PERMIT

SEWAGE DISPOSAL SYSTEM

SUBDIVISION Walnut Springs LOT 12 ROAD 1270 Emmaus Road

LDE, Inc. 9250 Rumsey Road, Suite 106 Columbia, Maryland (410)715-1070 - (301)596-3424 - Fax(410)715-9540		Plot Plan LOT 12 - WALNUT SPRINGS 4th Election District Howard County, Maryland	
		Scale: 1"=50' Date: Aug 1996	LDE Job # 96-046 Sheet 1 of 1

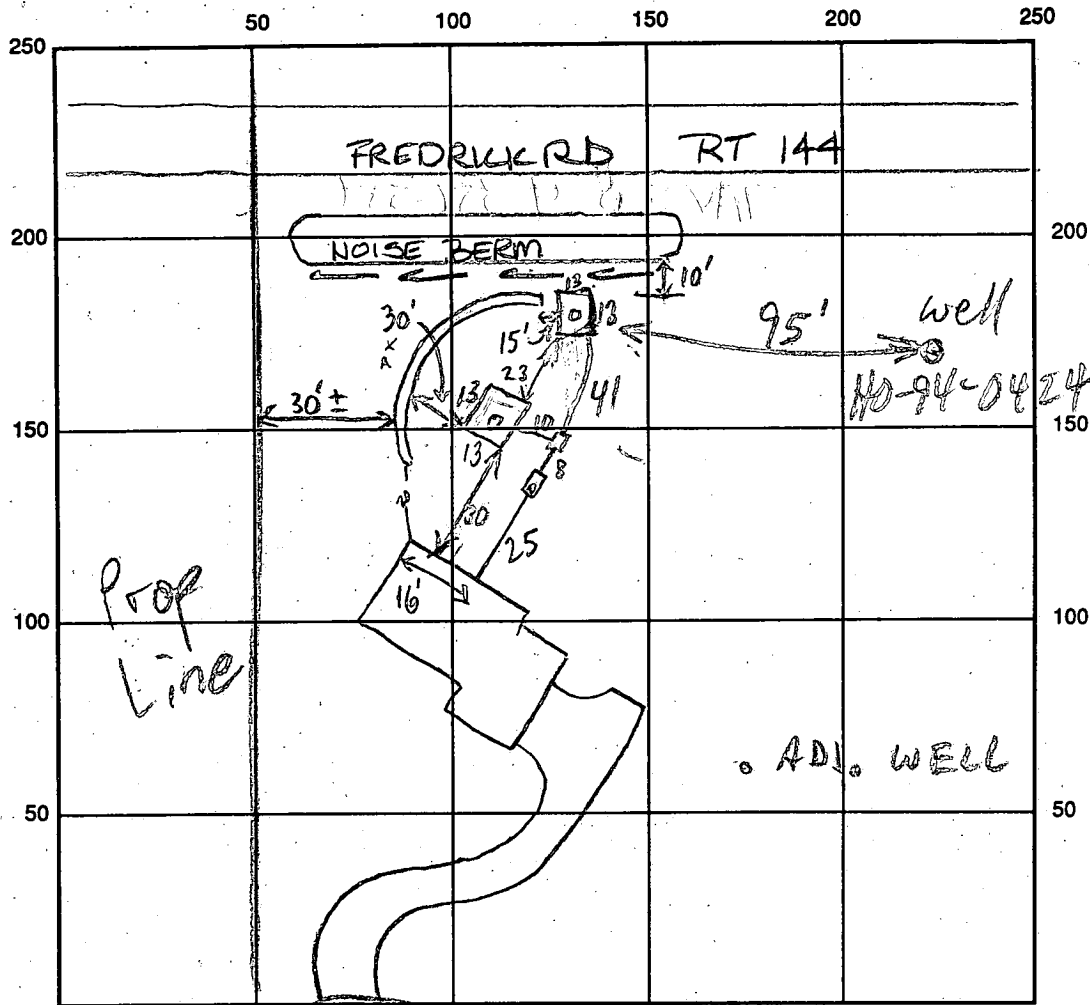
SPECS REVISED:
2 13 x 13" D/W WITH C/O, NO RINGS, AS HIGH AS POSS. OK TO MAINTAIN 15' TO WELL; MAINTAIN MAX OFF ABANDONED TRENCH MR 12/2/96

REMARKS: 11/15/96 stop work - house moved, noise berm in SDA & 1st trench
has 250% ex of 5.0' Test hole 10' down from trench #1 OK ALM
11/18/96 WALL CHECK REC'D, HOUSE LOC. OK MR
12/2/96 MET BLDR & KENNY @ SITE; 30-40% SEPTIC AREA SEEMS
LOST; BEST OPTION IS 2 13'x13' DRYWELLS MR
12/10/96 OK TO COVER ALL MR
 DATE SYSTEM APPROVED 12/10/96 INSPECTOR M. Ritkin

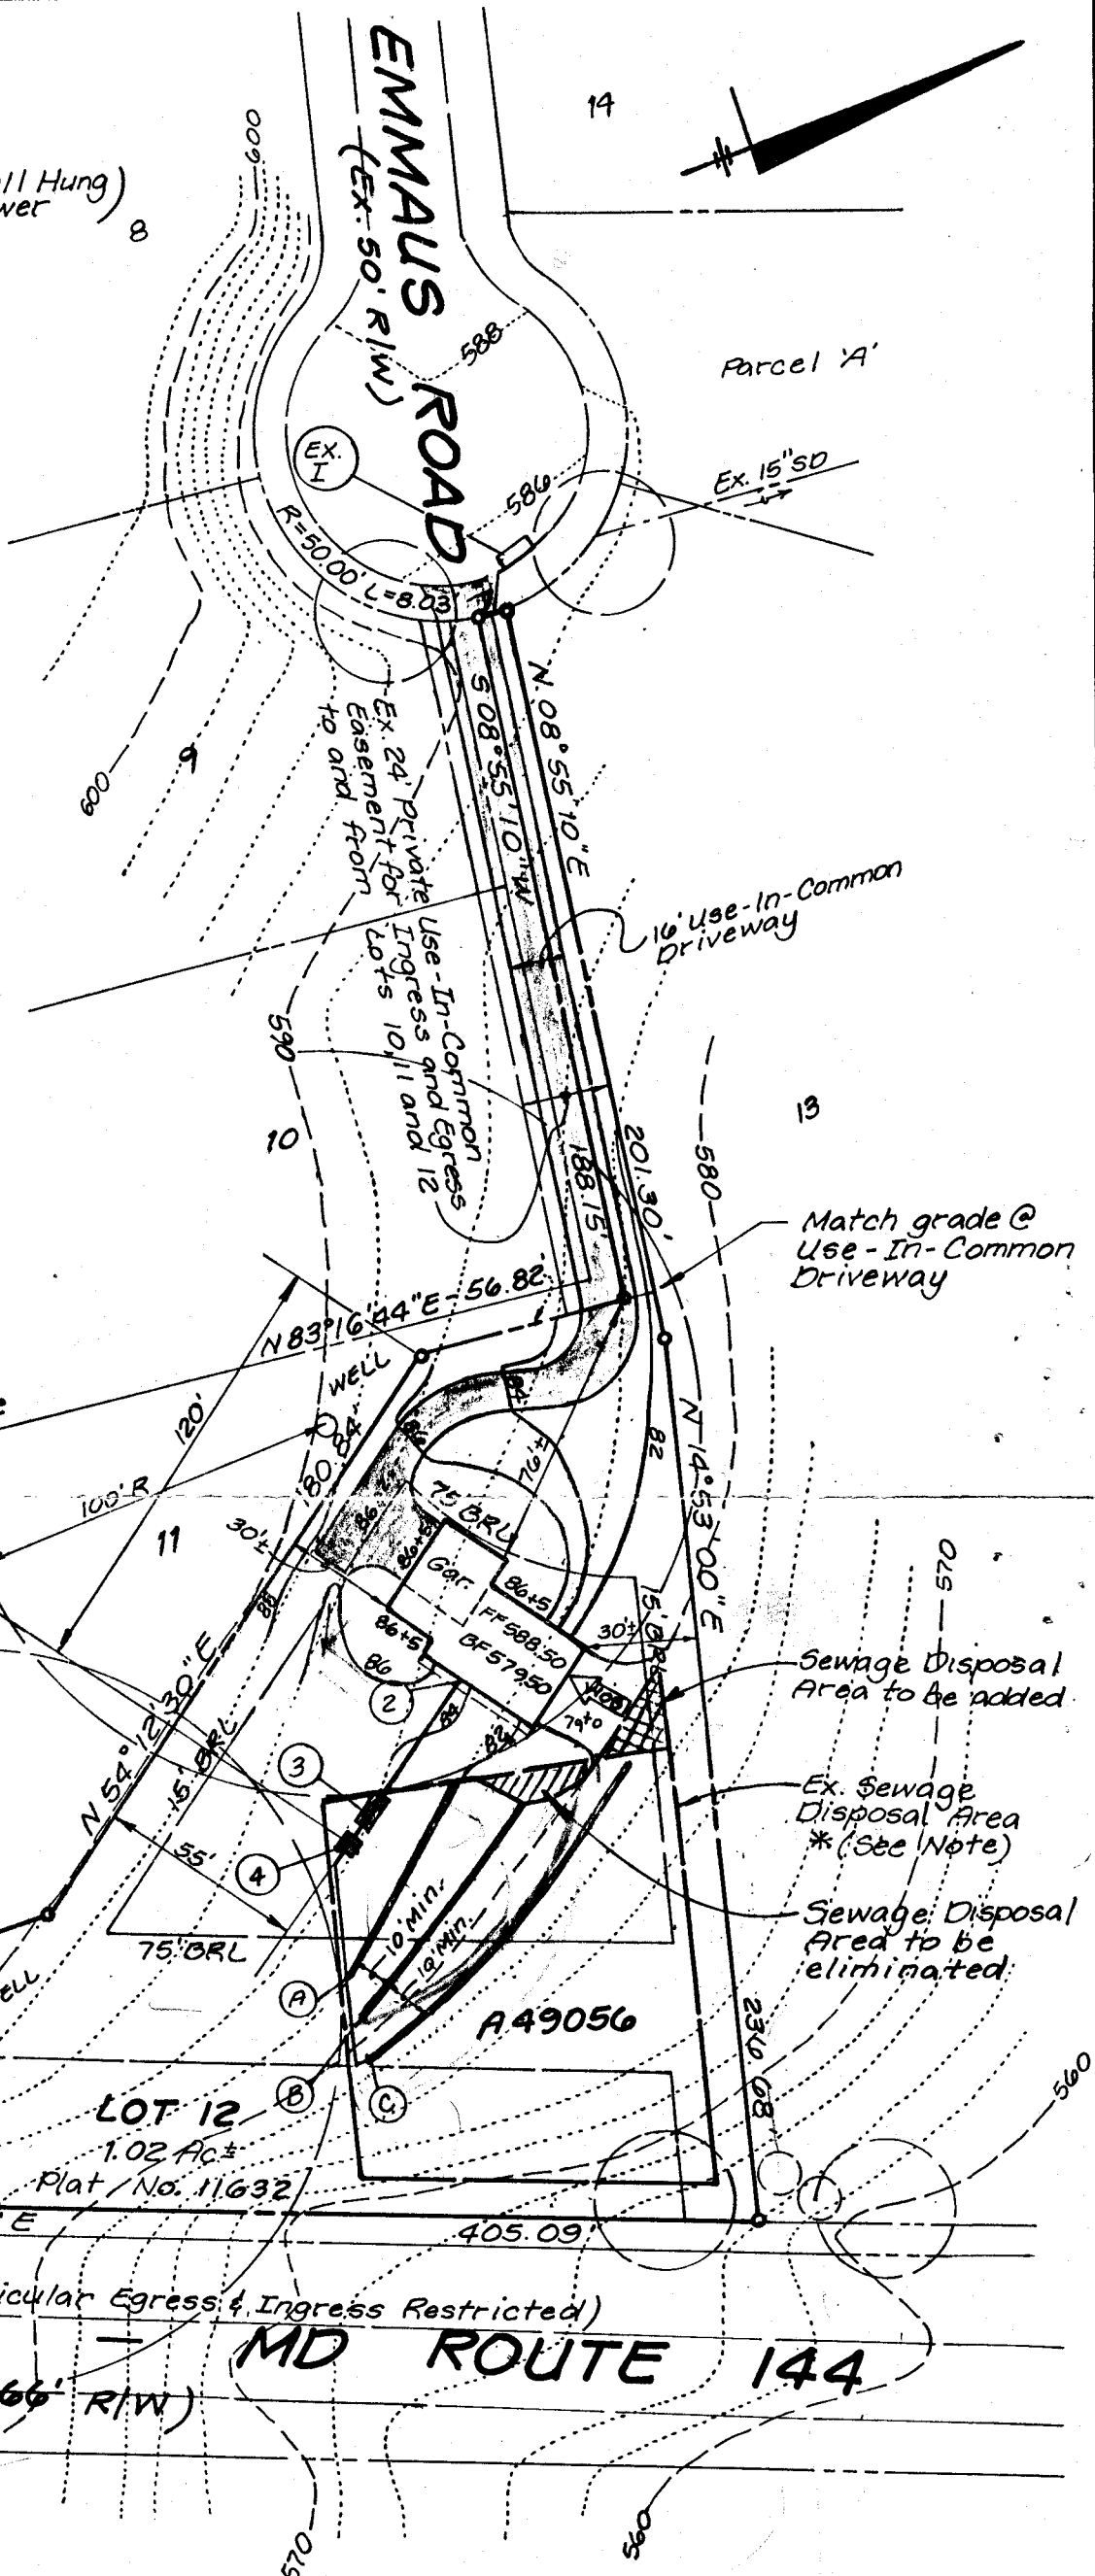
Sewage Disposal Area to be added.
Ex. Sewage Disposal Area * (See Note)
Sewage Disposal Area to be eliminated.

* **NOTE:** BY COPY OF THIS PLAN THE HEALTH DEPARTMENT ACCEPTS THIS MODIFICATION TO THE RECORDED SEWAGE EASEMENT.
